**TECHNICAL BULLETIN****TB-25-003****Title:** Minimum Clearances and Connection of Service Drops to a Building and to a Concrete Column**Issue Date:** 10/10/2025**Effective Date:** 10/15/2025**Department:** Distribution Standards and Materials**Addressed to:**

- Standard no. K-7-3-1, *Connection of Secondary Triplex Cable Service Drop to Customer's Concrete Column* (document no. 4301.095), version 7, dated February 7, 2024
- Standard no. M-5-A, *Minimum Clearances Required for Service Drop and Between Power Lines and Structures* (document no. 4301.098), version 8, dated December 19, 2023

B. A new standard was developed to provide detailed instructions for connecting a secondary triplex cable service drop directly to a building: standard no. K-7-5, *Connection of Secondary Triplex Cable Service Drop to a Building* (document no. 4301.09.176), dated October 10, 2025.

**FIGURE D**  
FRONT VIEW

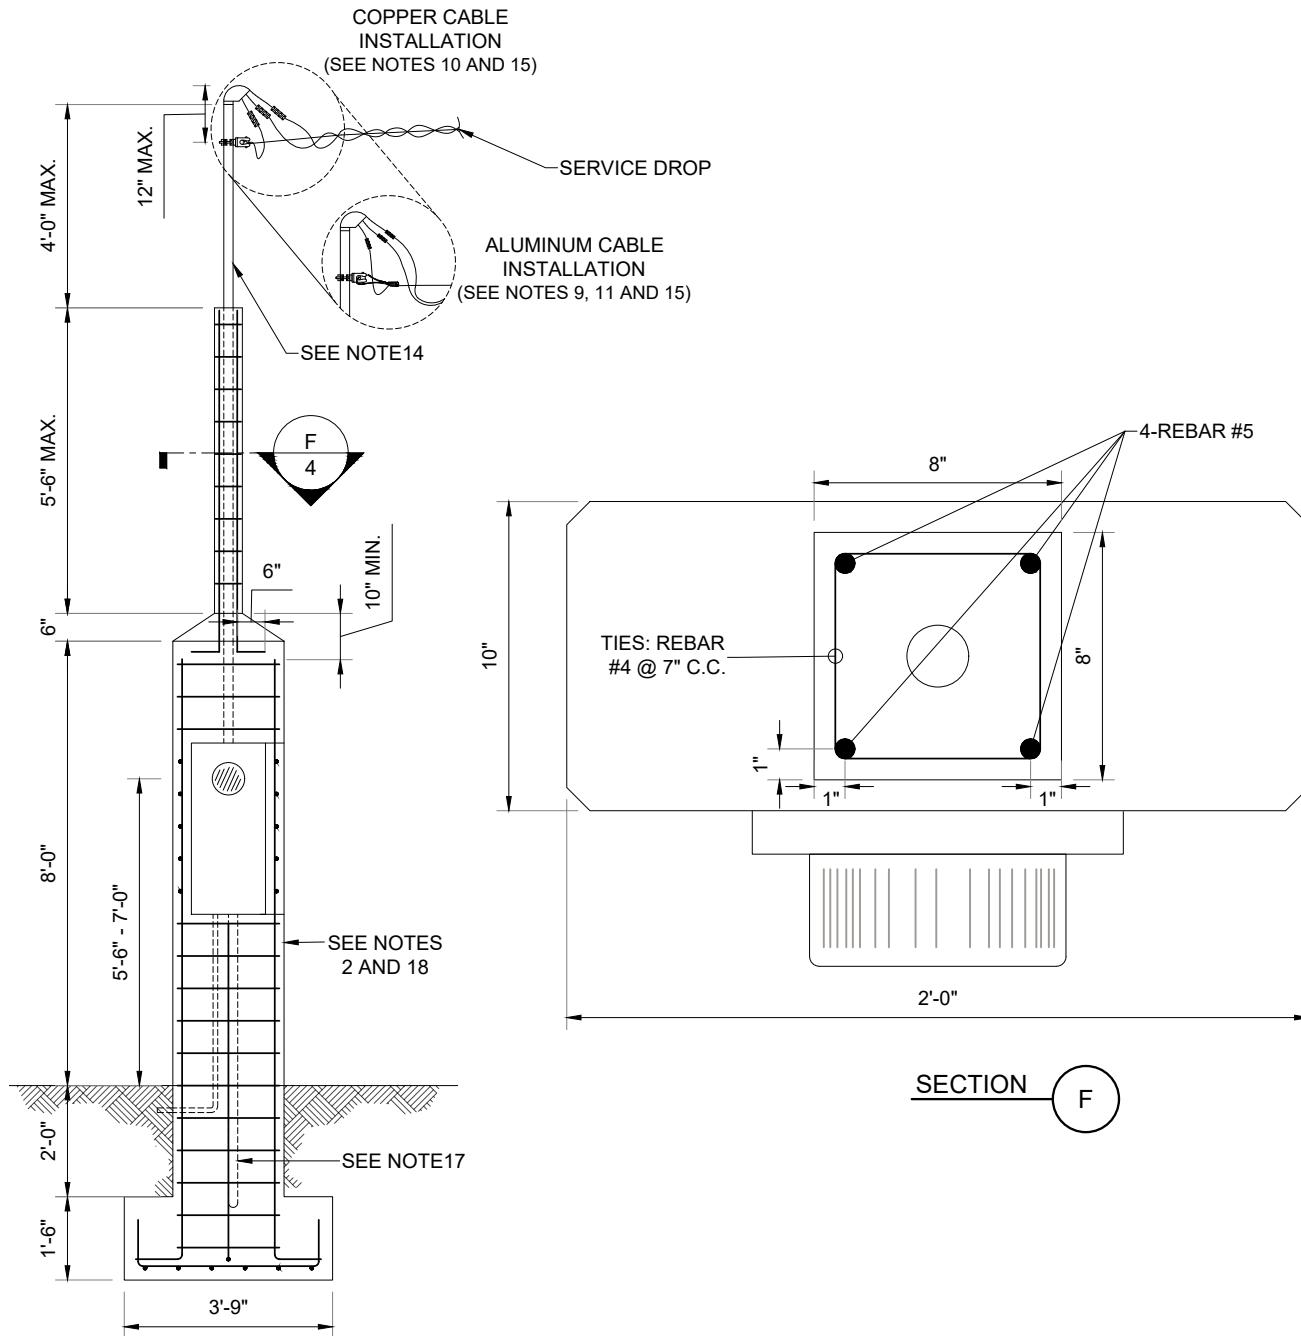
- a. Provision to extend the reinforced concrete column's height if additional clearance is required.
- b. Option to install a reinforced concrete column without a meter socket box in backyards for the service drop connection in the event of any obstacle, clearance, or distance challenges.
- c. Extension of the concrete column's dimension to ensure it fits a meter bank.
- d. Material options for the working space surface.

6. THE REINFORCED CONCRETE COLUMN SHOWN IN FIGURE A SHALL BE USED AS LONG AS THE SERVICE DROP CLEARANCE REQUIREMENTS OF STANDARD NO. M-5-A ARE MET. IF ADDITIONAL CLEARANCE IS REQUIRED, THE COLUMN MAY BE EXTENDED TO A HEIGHT OF UP TO 18'-0". FOR THIS PURPOSE, THE EXTENDED HEIGHT REINFORCED CONCRETE COLUMN SHOWN IN FIGURE D SHALL BE USED.

FIGURE E  
FOOTING DETAIL FOR CONCRETE COLUMN  
SUPPORTING MULTIPLE METERS

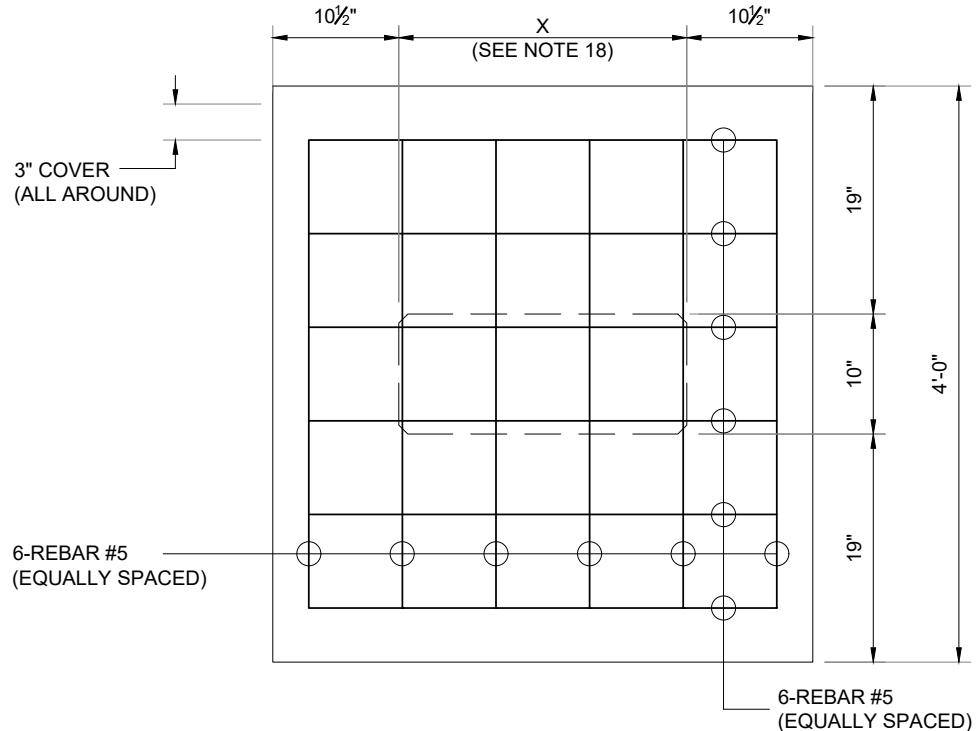
17. A 2" MINIMUM DIAMETER DUCT SHALL BE USED FROM THE METER SOCKET BOX TO THE STRUCTURE AND INSTALLED AT A MINIMUM DEPTH OF 2'-0".
18. THE DESIGN OF THE REINFORCING STEEL DETAILED ON SECTION A OF FIGURE C USED FOR A CONCRETE COLUMN WITH A SINGLE METER CAN BE REPLICATED TO THE NECESSARY SIZE FOR A CONCRETE COLUMN WITH MULTIPLE METERS (METER BANK). THE CONCRETE COLUMN FOOTING DIMENSION X SHALL BE INCREASED ACCORDING TO THE NECESSARY SIZE TO INSTALL THE REQUIRED METERS (SEE FOOTING DETAIL ON FIGURE E).

FIGURE F  
WORKING SPACE

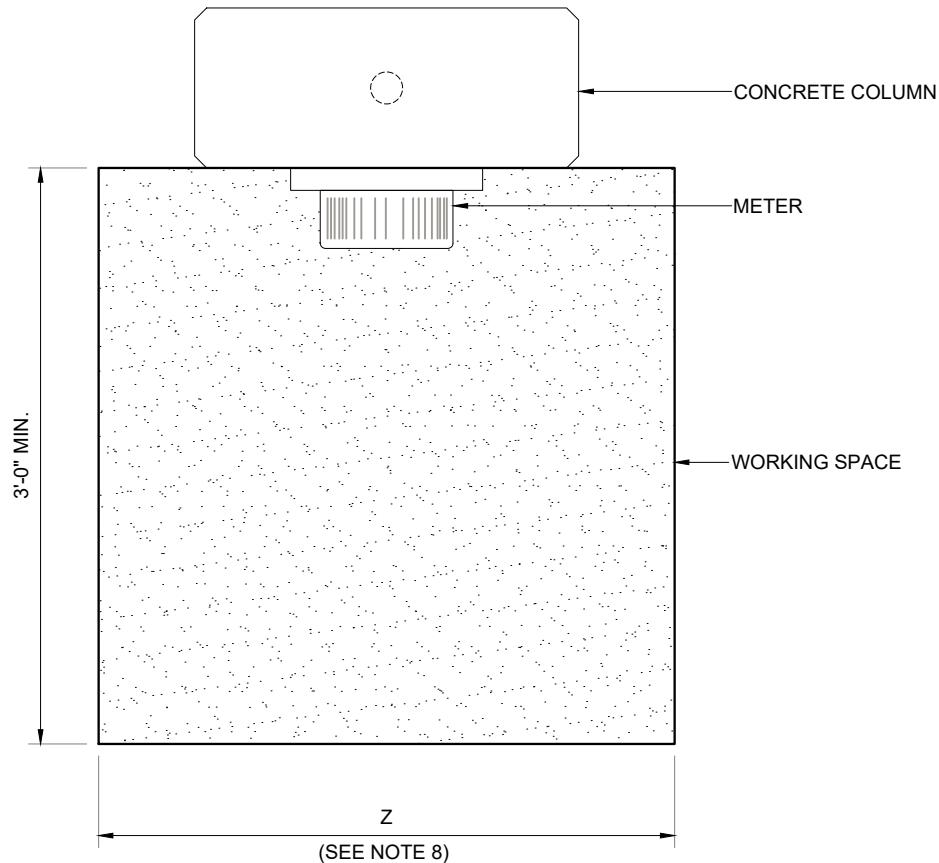
8. A WORKING SPACE OF AT LEAST 3'-0" X 3'-0" WITH A MAXIMUM SLOPE OF 2% AND A MAXIMUM HEIGHT OF 7" MUST BE AVAILABLE IN FRONT OF THE METER SIDE OF THE CONCRETE COLUMN TO GUARANTEE A SAFE OPERATION AND MAINTENANCE. THE WORKING SPACE SHALL BE BUILT WITH CONCRETE, ASPHALT, COMPACTED SOIL OR GRAVEL. LUMA RESERVES THE RIGHT TO DECLINE A COLUMN OR REQUIRE ADDITIONAL SAFETY FEATURES IN AREAS WITH UNEVEN SURFACES OR INSUFFICIENT CLEARANCES. THE WORKING SPACE WIDTH (Z) SPECIFIED IN FIGURE F SHALL BE INCREASED ACCORDING TO THE CONCRETE COLUMN SIZE TO PROVIDE AN ADEQUATE WORKING SPACE.

ELEVATION VIEW

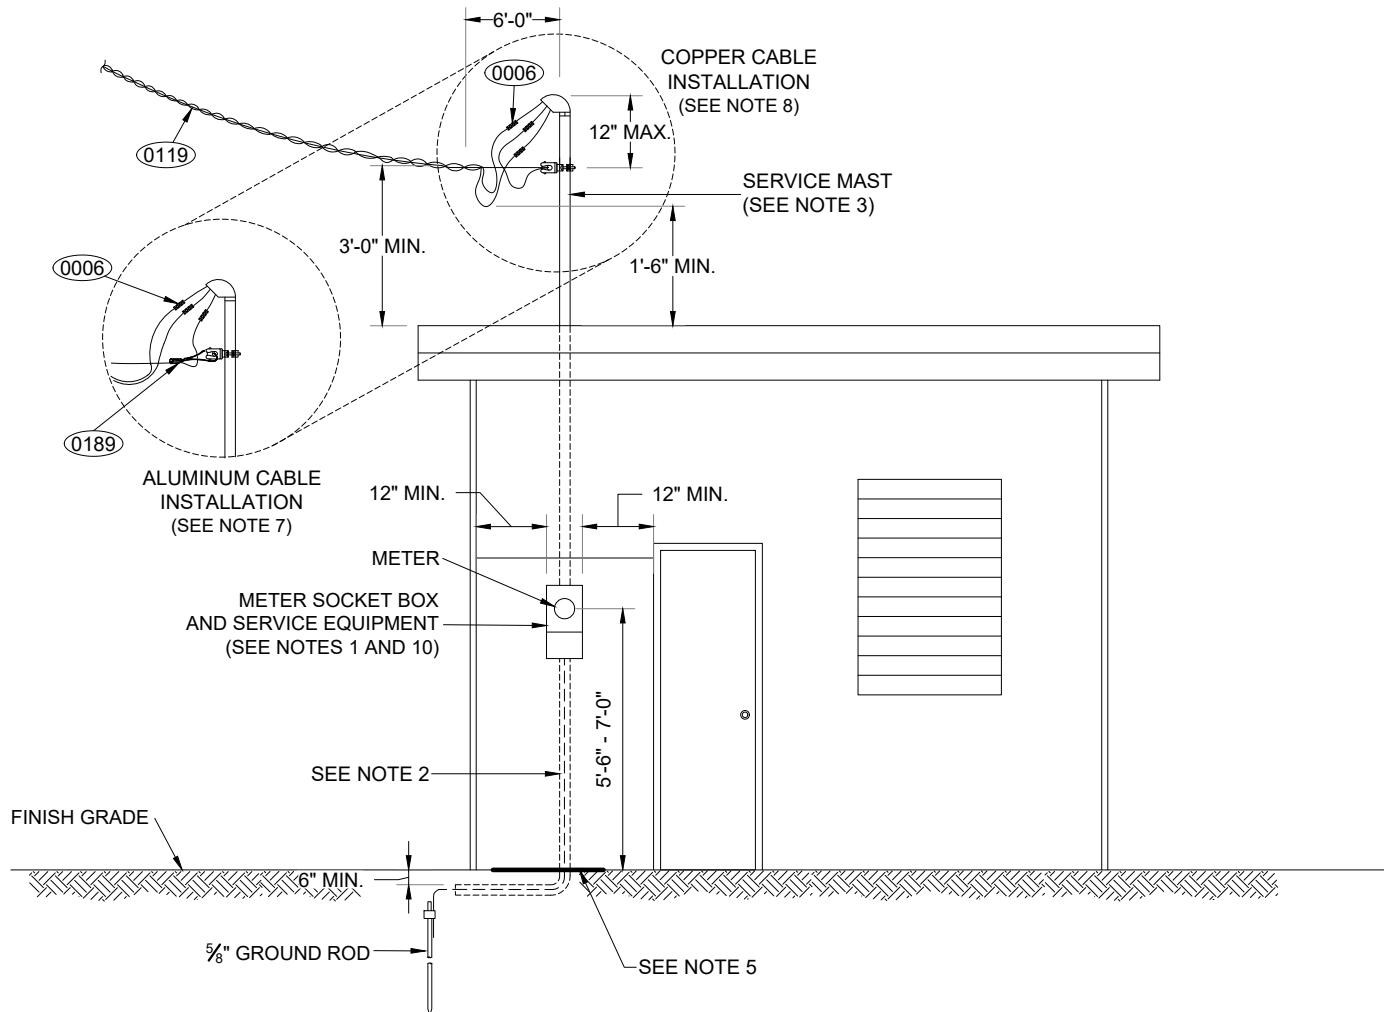
- a. Detailed instructions for connecting the secondary triplex cable service drop directly to a building, based on the type of material used.
- b. Specific location to install the meter base.
- c. Working space requirement for safe operation and maintenance.
- d. Visual aids and diagrams to support proper implementation.

**FIGURE A**  
TRANSITIONAL CLEARANCE WHEN V IS GREATER THAN H  
(SEE NOTE 3)

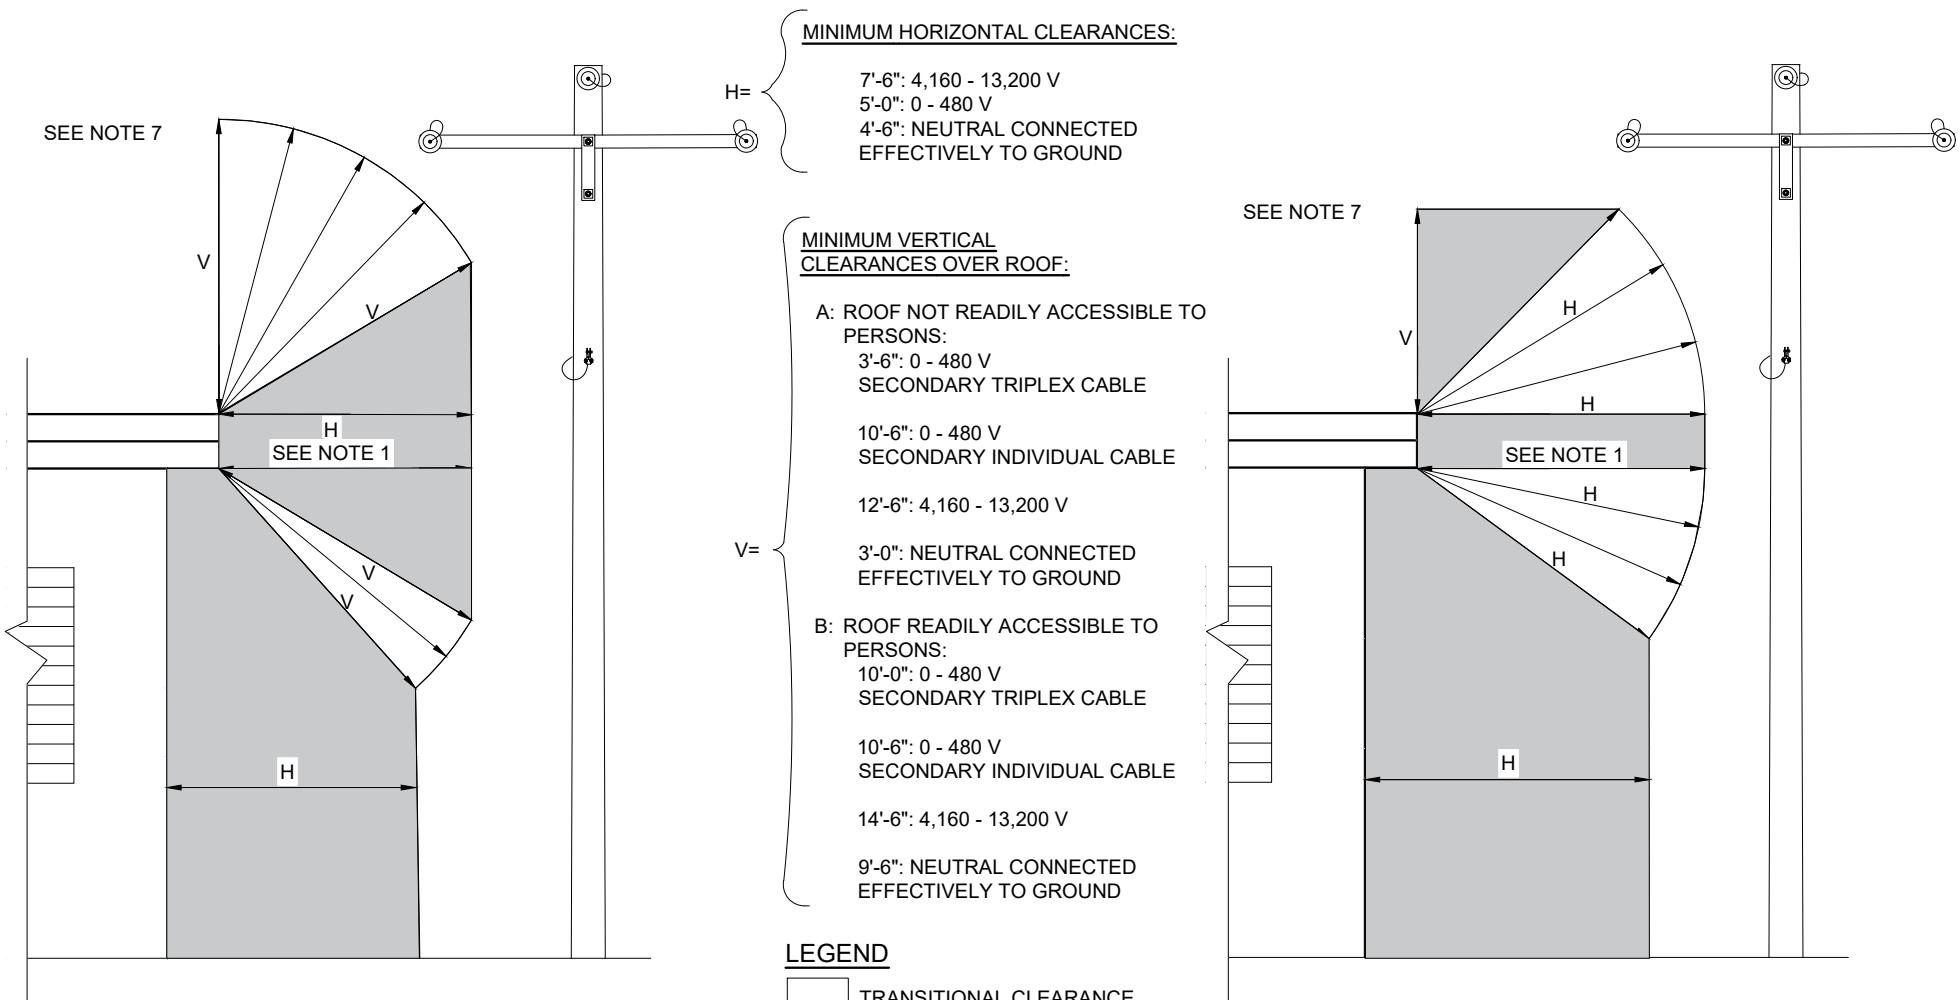
- a. Inclusion of visual aids showing vertical and horizontal clearances.
- b. Specification of clearance requirements when  $V$  (vertical) is greater than  $H$  (horizontal) and vice versa.

3. WHEN THE VERTICAL CLEARANCE (V) IS GREATER THAN THE HORIZONTAL CLEARANCE (H), THE HORIZONTAL CLEARANCE GOVERNS ABOVE THE LEVEL OF THE ROOF OR TOP OF AN INSTALLATION TO THE POINT WHERE THE DIAGONAL EQUALS THE VERTICAL CLEARANCE REQUIREMENTS.

4. WHEN THE HORIZONTAL CLEARANCE (H) IS GREATER THAN THE VERTICAL CLEARANCE (V), THE VERTICAL CLEARANCE GOVERNS BEYOND THE ROOF TO THE POINT WHERE THE DIAGONAL EQUALS THE HORIZONTAL CLEARANCE REQUIREMENT.

MINIMUM VERTICAL CLEARANCES FOR A SERVICE DROP CONNECTED TO A BUILDING

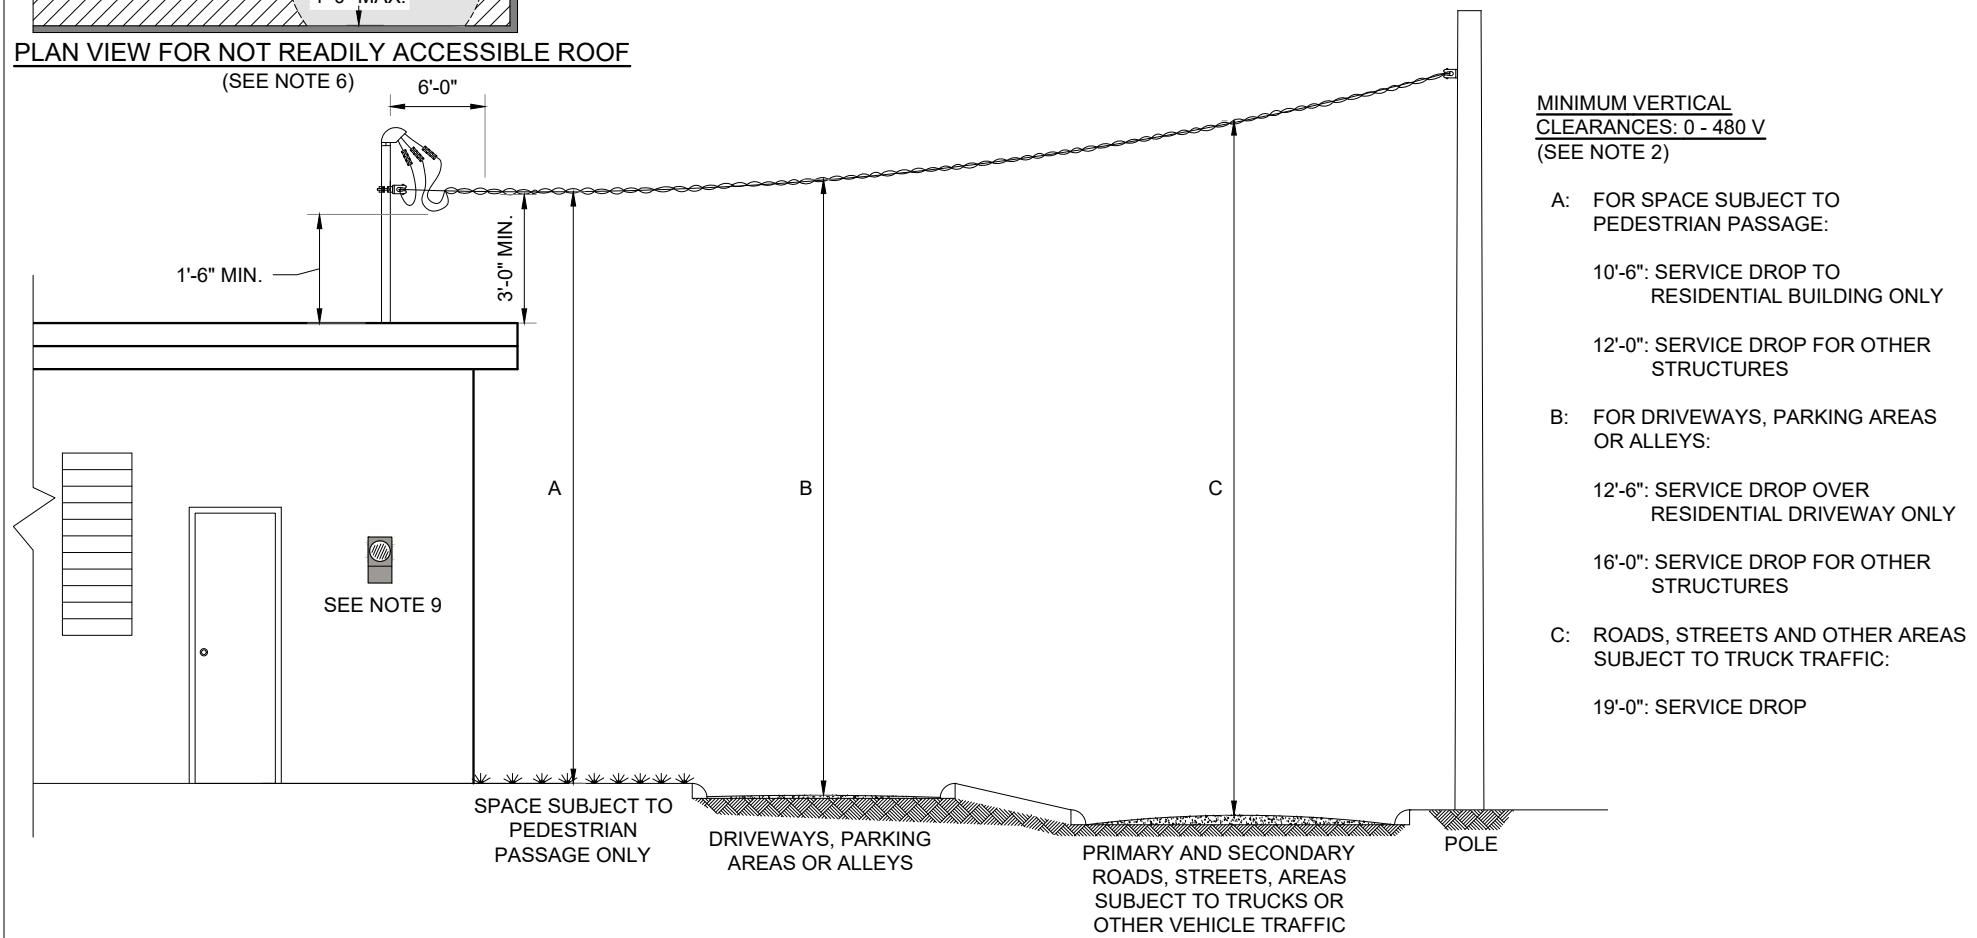
c. Addition of two new supplemental sheets with drawings showing minimum vertical clearances for a service drop connected to a building and to a customer's concrete column. These minimum vertical clearances will be permitted only for service drops where the height of the structure or adjacent installations does not allow to comply with the required minimum clearances included in current standard no. M-5, *Minimum Vertical Clearances Required for Power Lines Above Ground or Roadway* (document no. 4301.097).

2. THESE MINIMUM VERTICAL CLEARANCES WILL BE PERMITTED ONLY FOR SERVICE DROPS WHERE THE HEIGHT OF THE STRUCTURE OR ADJACENT INSTALLATION DOES NOT ALLOW THE MINIMUM CLEARANCES REQUIRED IN STANDARD NO. M-5 TO BE MET. THESE CLEARANCES ARE THE MINIMUM PER NESC TABLE 232-1 WITH NO BUFFERS INCLUDED.
